## **CITY OF RACINE DEPARTMENT OF CITY DEVELOPMENT STAFF REPORT**

**Location:** 1339 17<sup>th</sup> Street by intersection of 17<sup>th</sup> Street and Holborn Street

**Request:** Consideration of a major amendment to a conditional use permit to add a building to the existing recycling yard at 1339 17<sup>th</sup> Street. A recycling drop-off site is allowed as a conditional use by Sec. 114-588 of the Municipal Code, The property is located in a I-2 General Industrial Zone District. The proposed use is to remain the same.

Proposed site layout with the new building and parking areas, submitted by applicant.

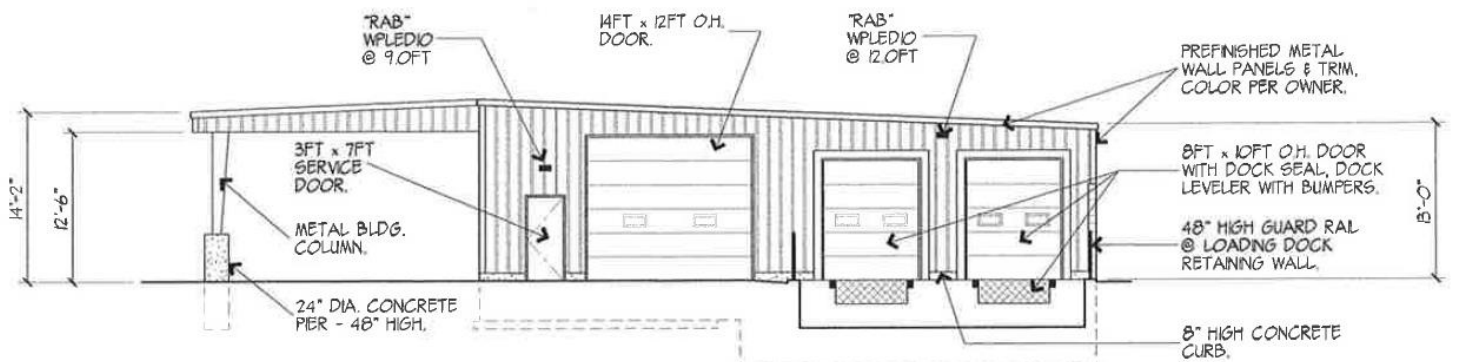
**Access** (114-[1151](#)): The site plan shows a new access drive off of 17<sup>th</sup> Street this new access will help with traffic flow for the site and will not be detrimental to existing traffic on the street.

Because of past buildings and structures there are multiple unused driveways along 17<sup>th</sup> Street. The unused driveways should be closed and proper curb and gutter installed.

Staff Comments: The site plan submitted by the applicant contemplates utilizing existing curb cuts and providing a U shaped access drive accessed from 17<sup>th</sup> street; the traffic flow is one way beginning at the easternmost driveway and ending up with parking lot, at the westernmost access. The access location onto the site is not along a major thoroughfare and the proposed access points will allow for some stacking of vehicles on the site and onto 17<sup>th</sup> Street, which has on-street parking.

4. Driveways along 17<sup>th</sup> Street not being utilized for the dropoff center be closed in accordance with Sec. 114-1151 and curbing in accordance with City standards installed.

Proposed west building elevation, submitted by applicant.

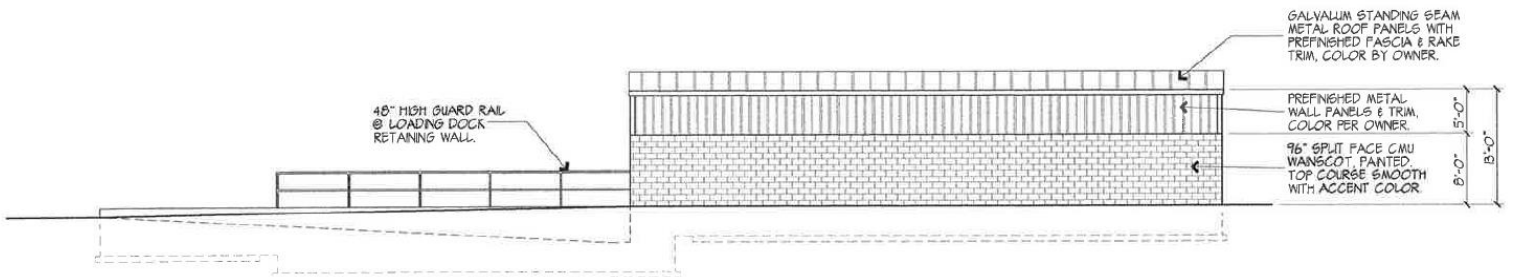
**Building design standards** (114-Secs. [735.5](#) & [736](#)): The proposed building does not comply with the construction materials requirements of 114.735.5 specified in the municipal code. The code requires that an accessory building have 30% of its façade be masonry. The proposed building is only 20% masonry. Additional masonry finish will be required on the building to comply with this development standard.

2. Masonry material as required by Sec. 114-735.5 be installed on at least 30% of the building walls. Masonry material shall be of a smooth face scored product to resemble full dimensioned jumbo brick. Revised plan indicating where the additional 10% masonry will be installed to be submitted to the Department of City Development, and approved by said Department, *prior to submitting for building permits*.
